ADDENDUM NO. 2

**New Premium 63 Site Loop Campground
St. Francois State Park
Bonne Terre, Missouri
PROJECT NO.: X2317-01**

August 29, 2025

SHEET TITLE:
DETAIL SHEET

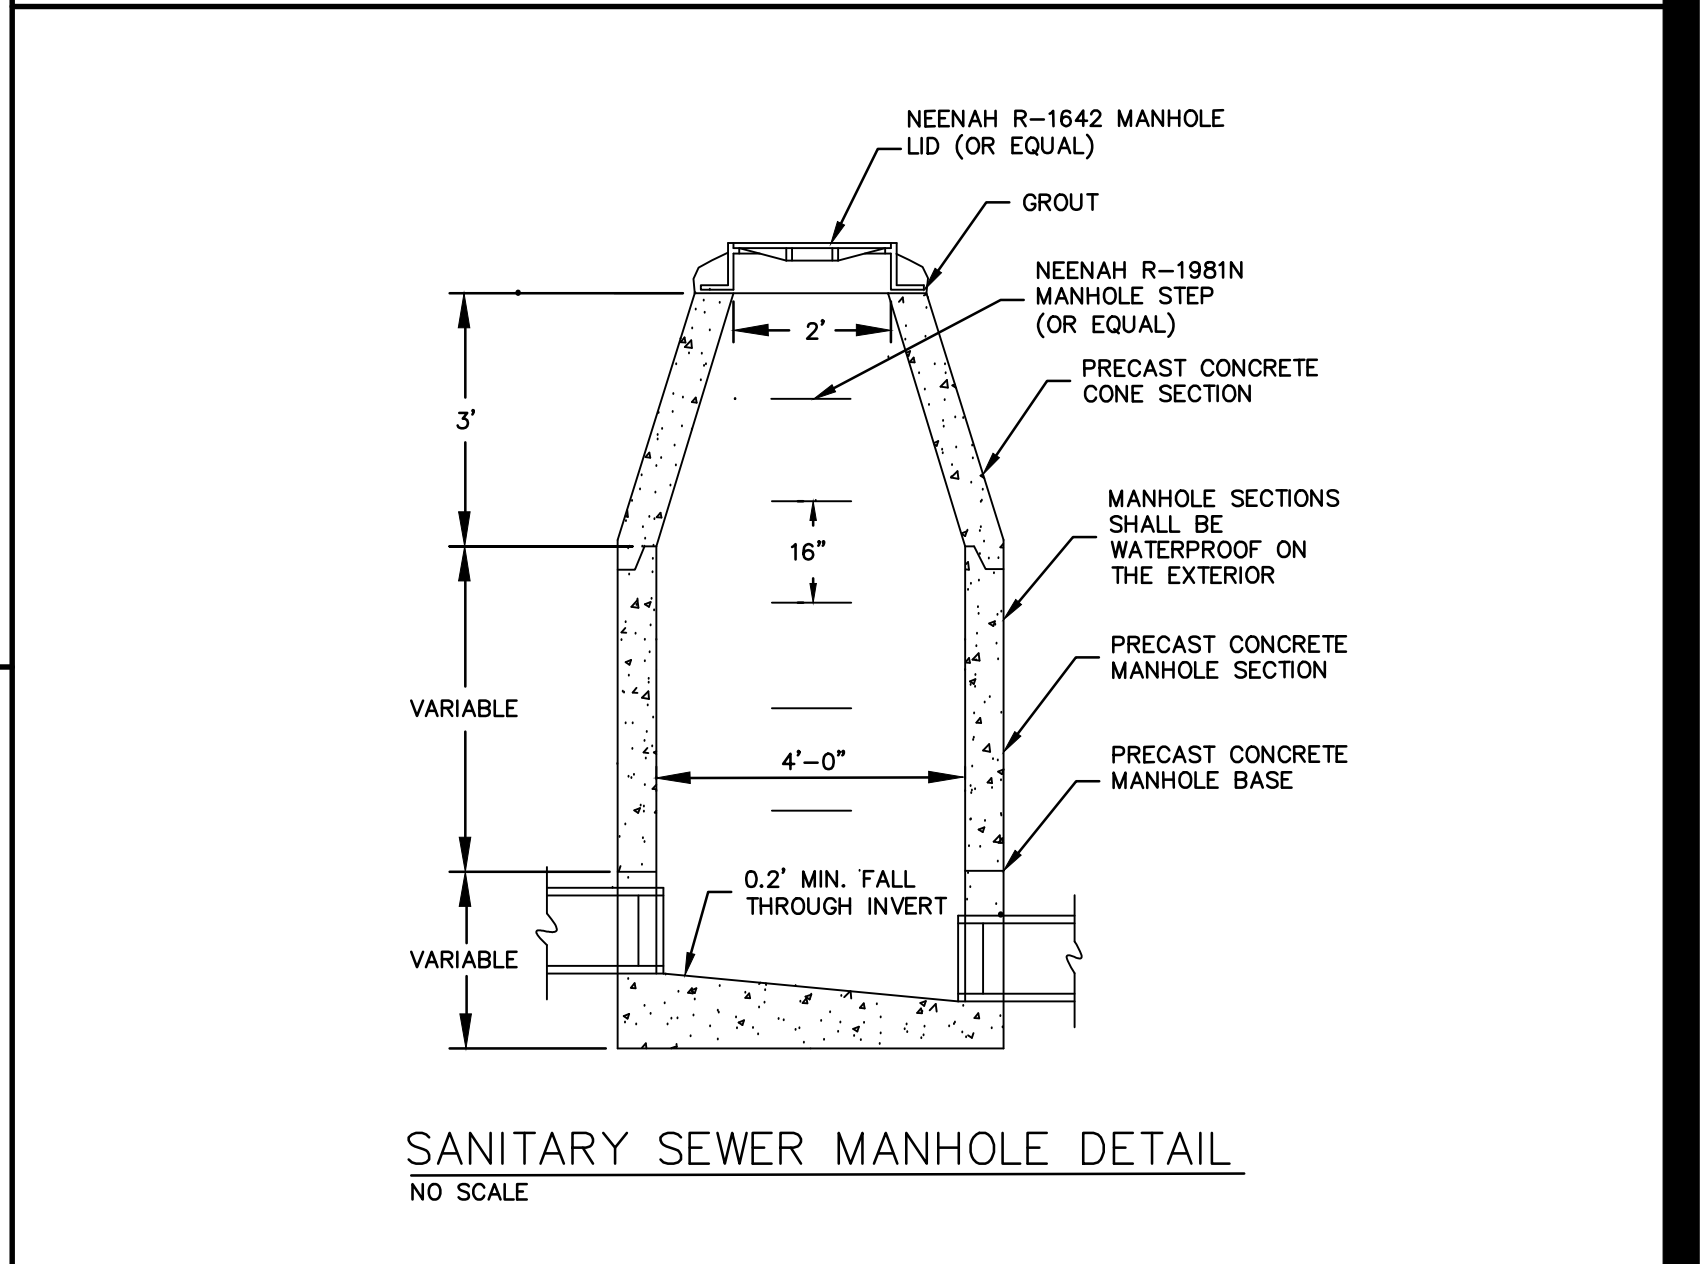
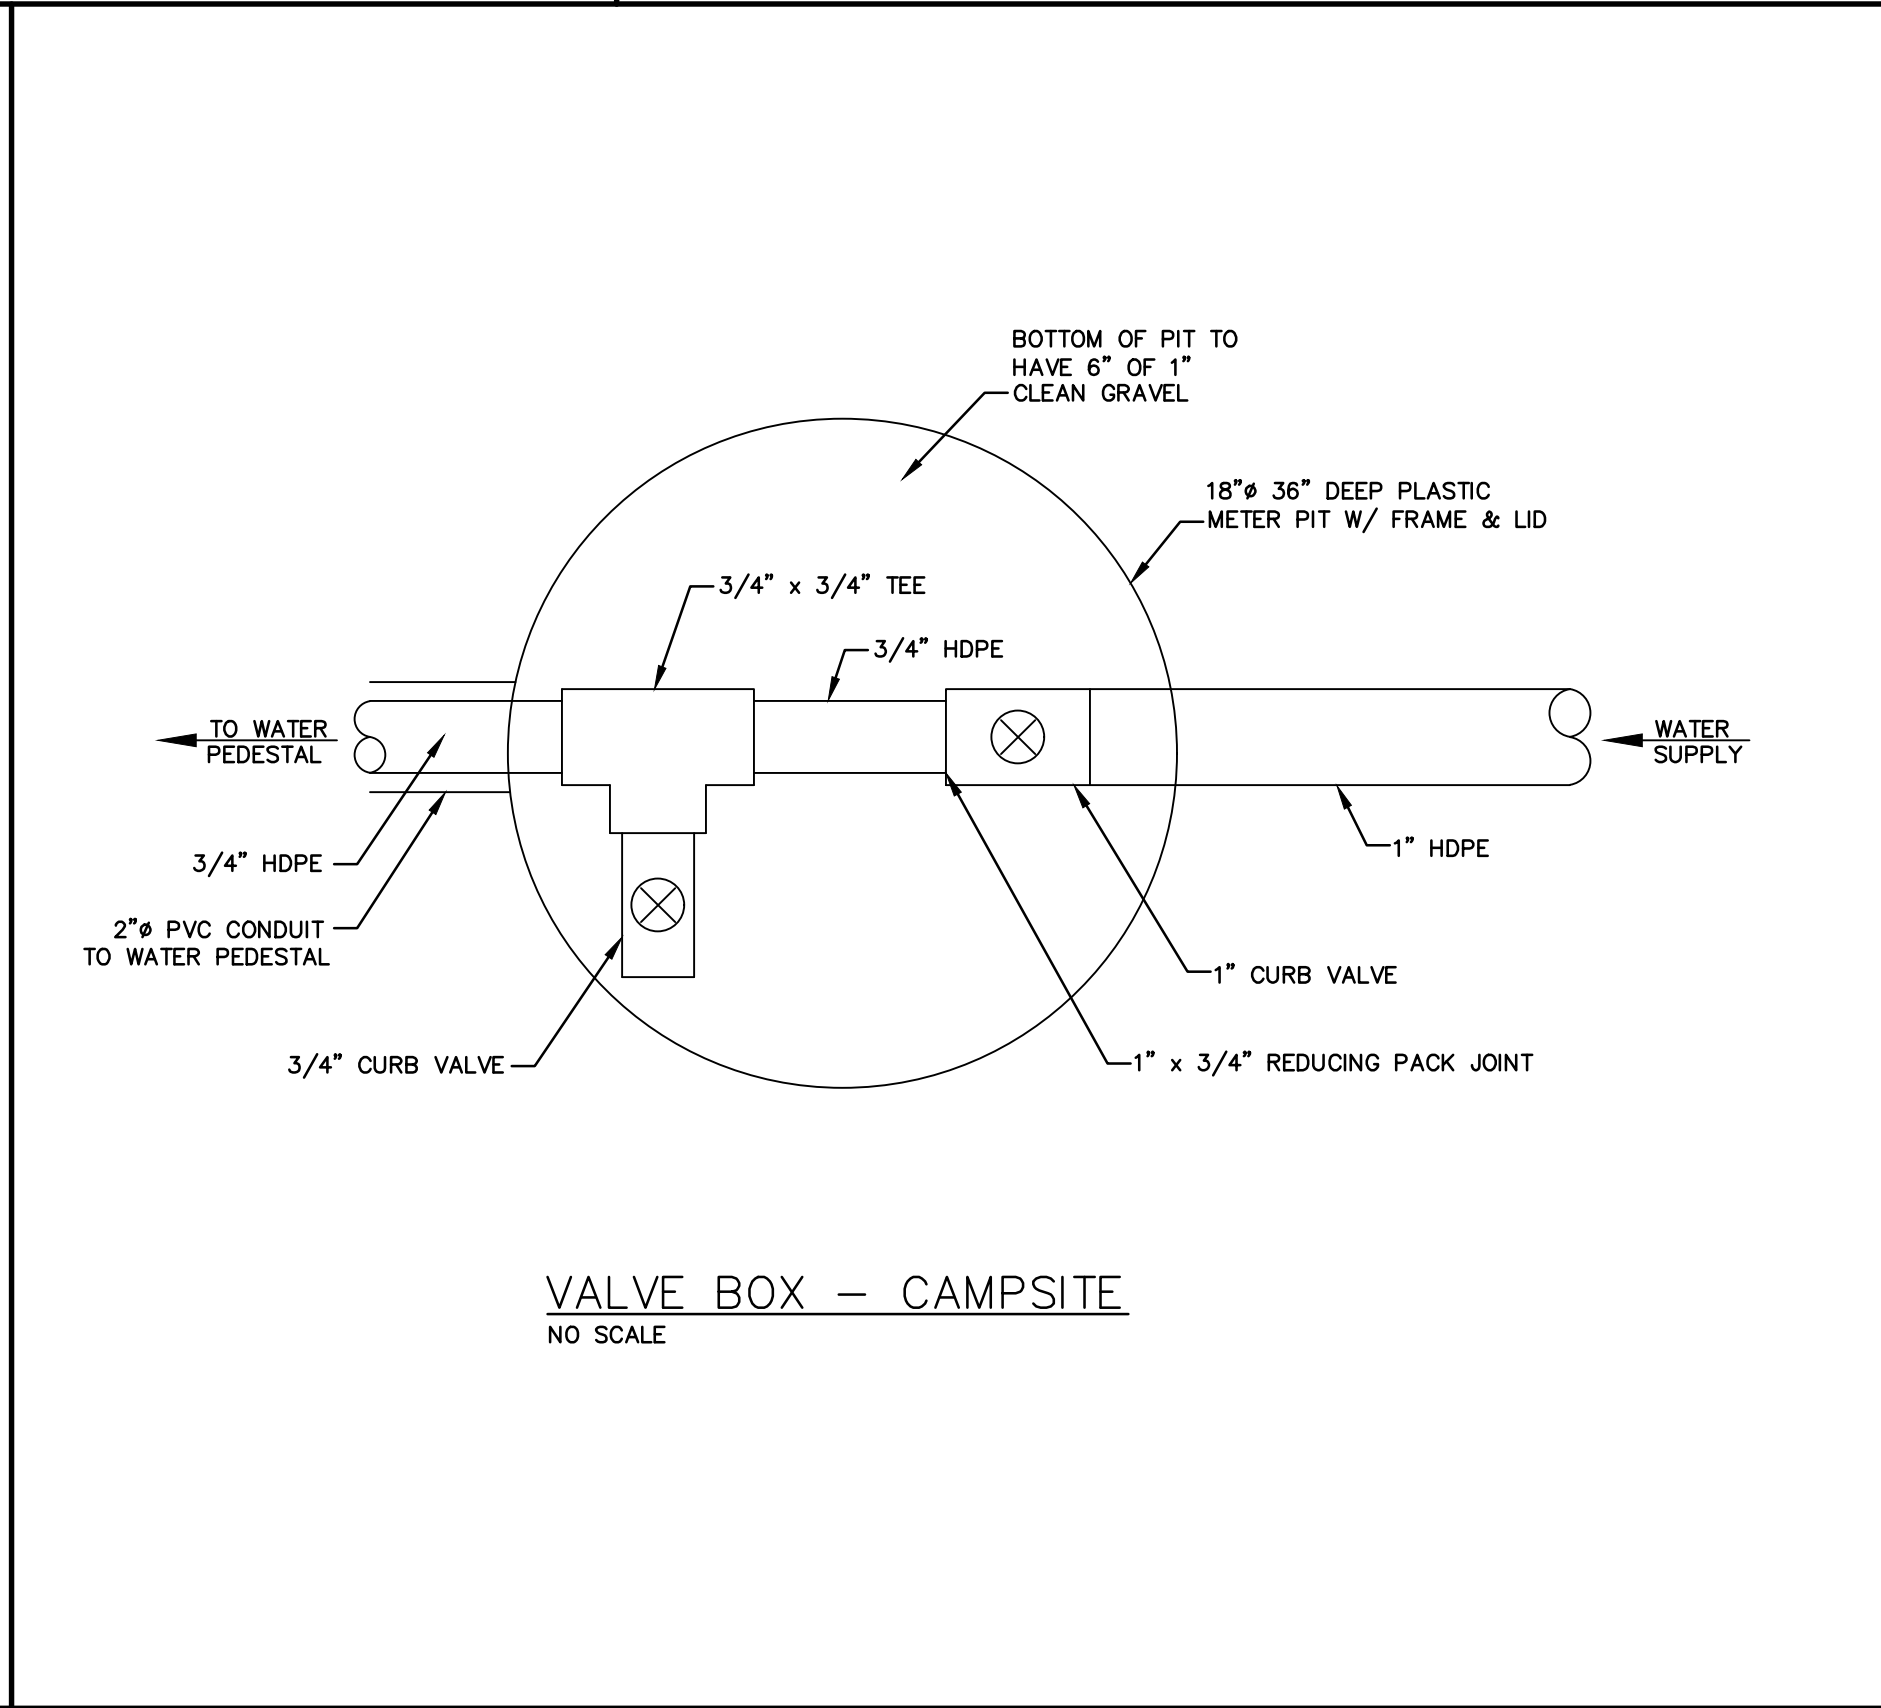
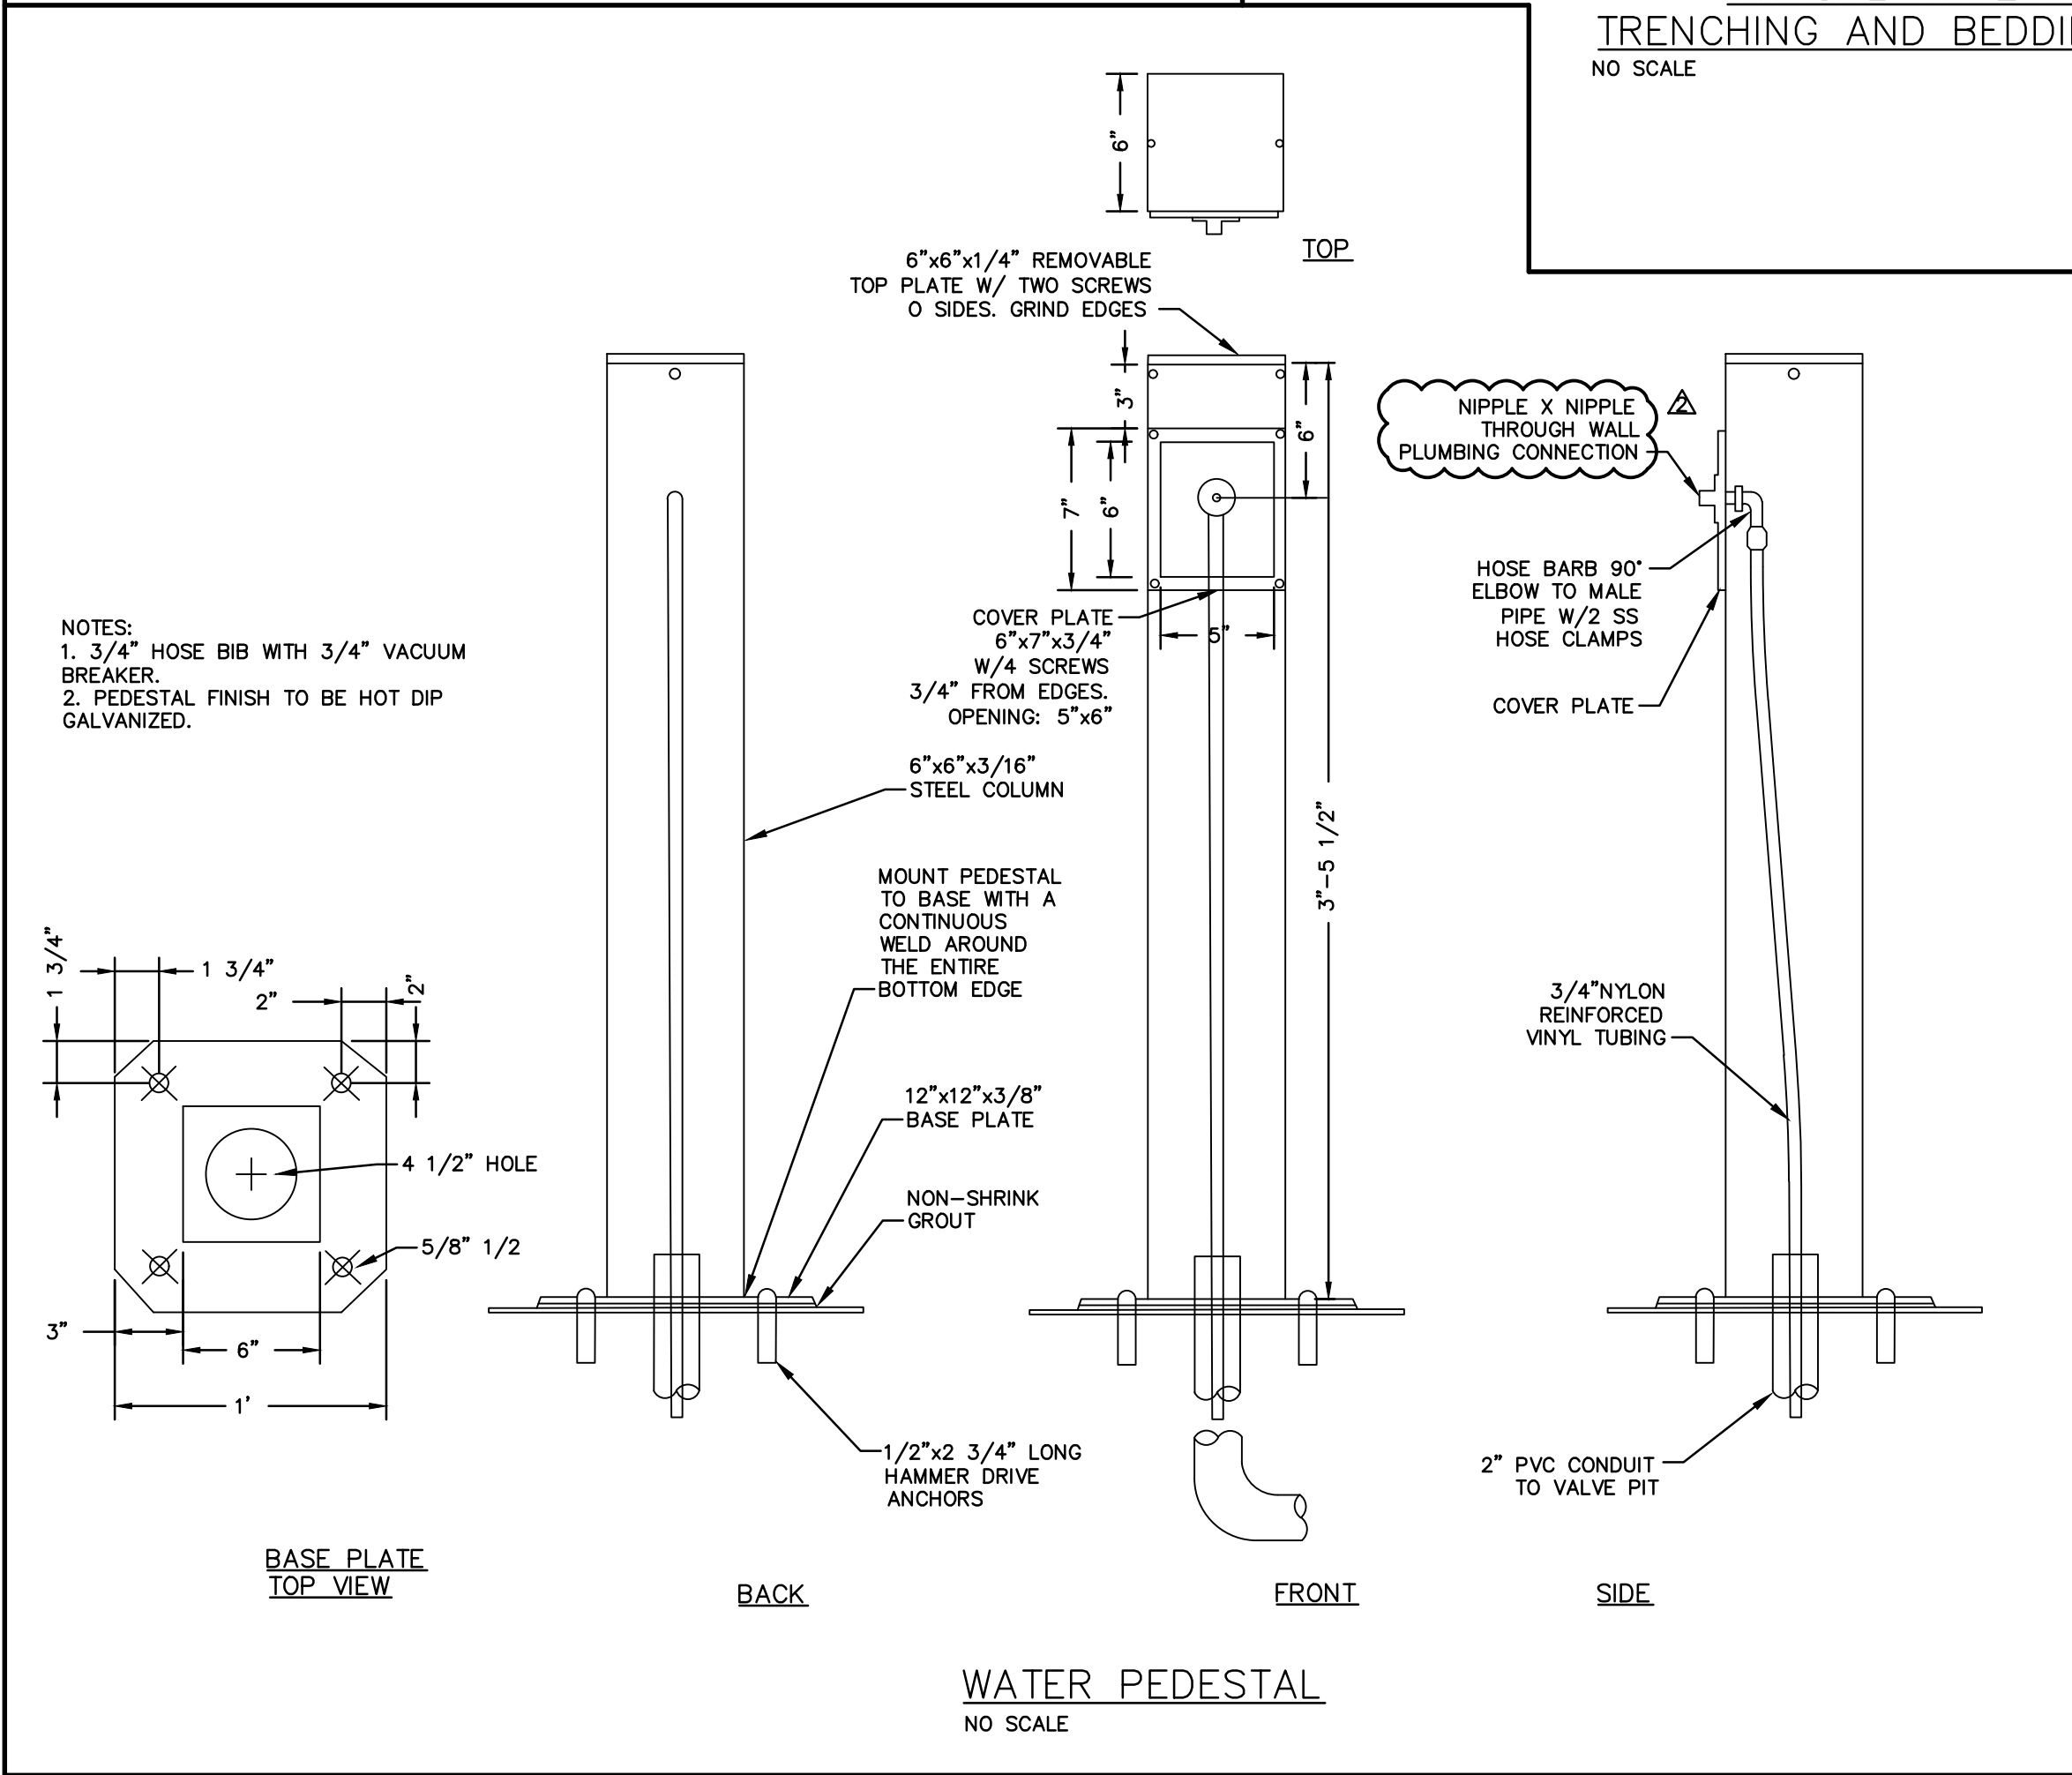
1. Three control joints have been added around the fire pits to avoid cracking.
2. Lantern hanger location moved to adjacent to the concrete pad as shown in the lantern detail.
3. Removed Alternate Concrete Paving Detail.
